Service Bulletin

SUBJECT: Service Update for Inventory Vehicles Only
Transmission Snap Ring Misalignment
Expires September 30, 2014

MODELS: 2013 Buick Regal, LaCrosse
2013 Chevrolet Malibu
Equipped with 6T40 Automatic Transmission (MHH)

3613040

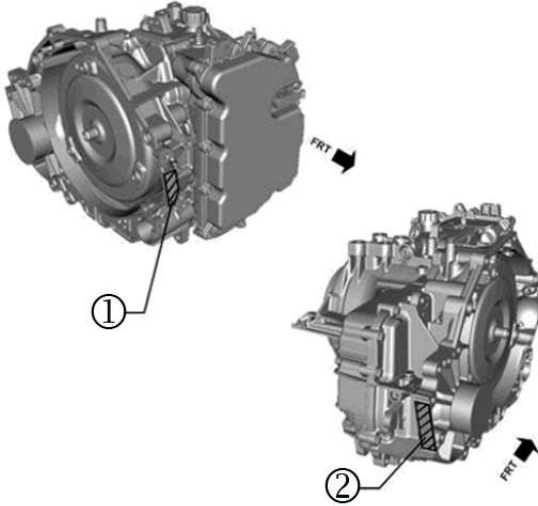
Note: A VIN derivative is required to be permanently engraved on the new transmission prior to installation. Refer to the illustration above for VIN engraving location points. Select one of the locations to engrave the required characters. VIN derivatives must be formatted as indicated below (# = last eight characters of the VIN).

Buick Regal and LaCrosse: 1J*4#####B

Chevrolet Malibu: 1J*1#####B
